**MELBOURNE METRO RAIL PROJECT ENVIRONMENT EFFECTS STATEMENT**  
**INQUIRY AND ADVISORY COMMITTEE**

**MMRA TECHNICAL NOTE**

**TECHNICAL NOTE NUMBER:** 008

**SUBJECT:** Soil and Rock Bore Logs

ATTACHMENT C:

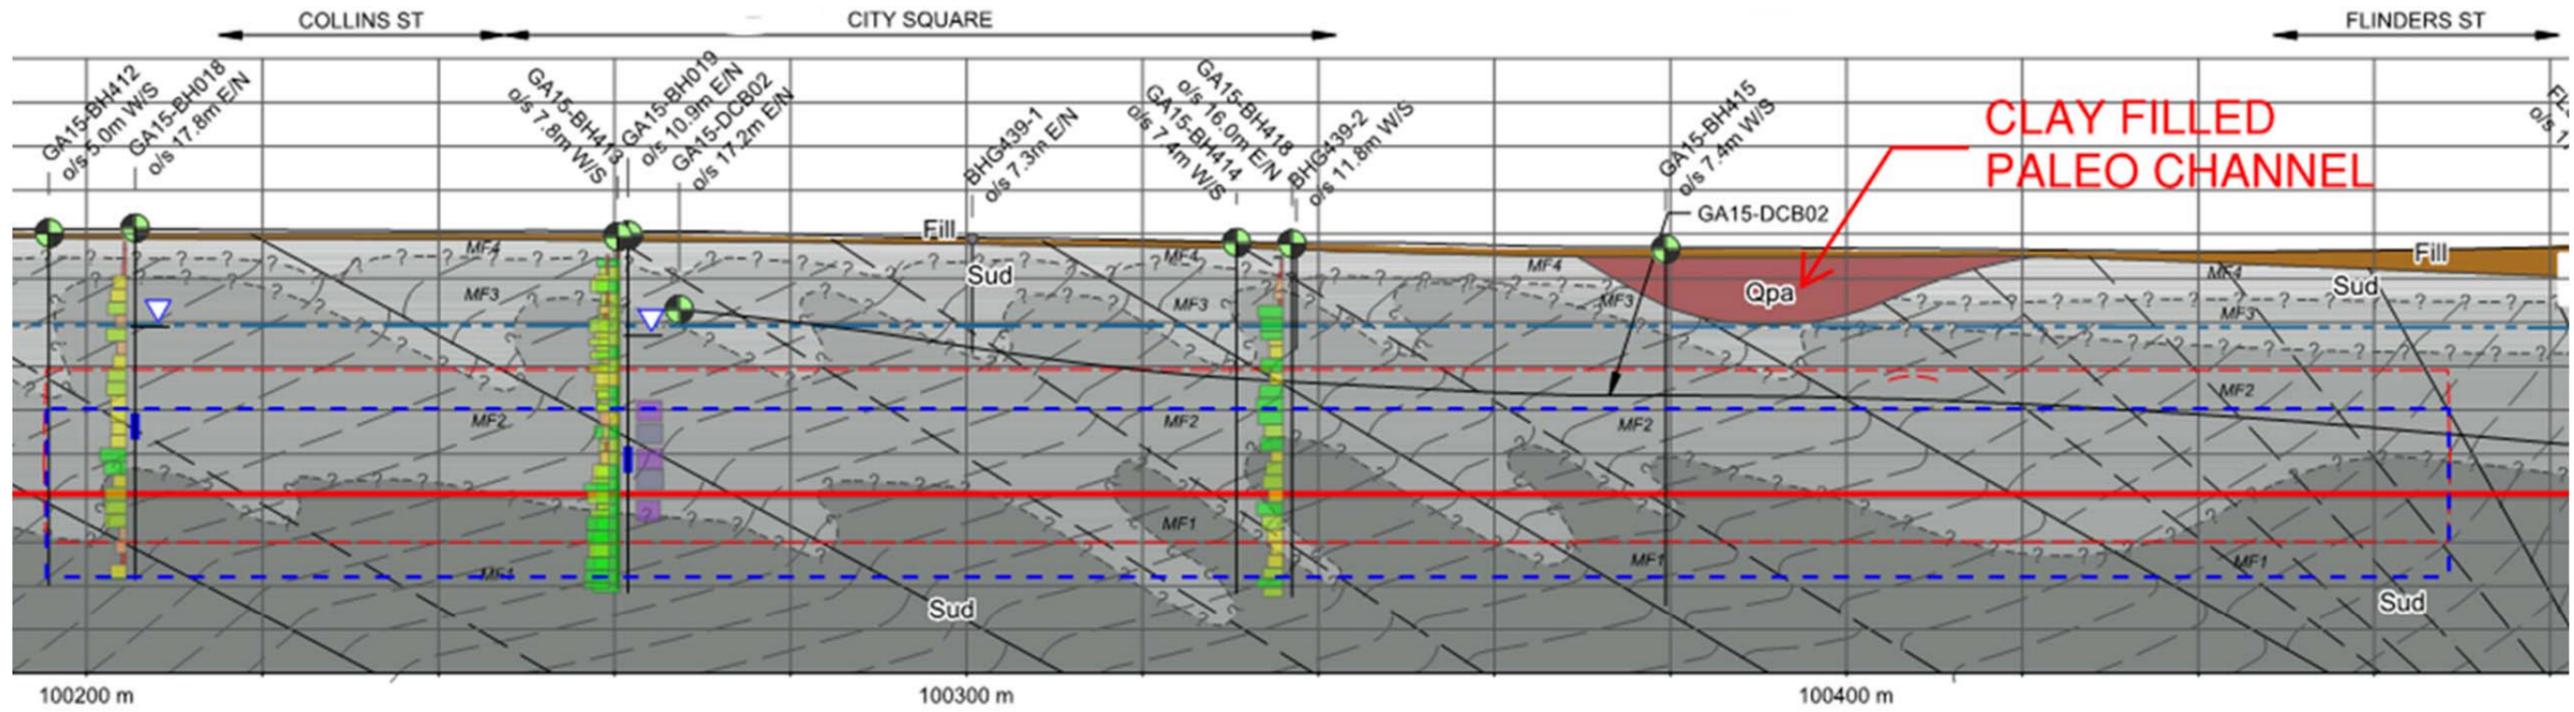
5. An outcome of the preliminary review of the updated geological information is the identification of a clay-filled paleo channel above the cavern at CBD South between Flinders Lane and Flinders Street, and deeper weathered rock profiles in the CBD Area.

6. For the purposes of the IAC assessment of the Concept Design, this note proposes a potential variation to the vertical depth of the CBD South Station by up to 4 metres.

- EES CONCEPT DESIGN CAVERN PROFILE
- 4m LOWERED CAVERN PROFILE
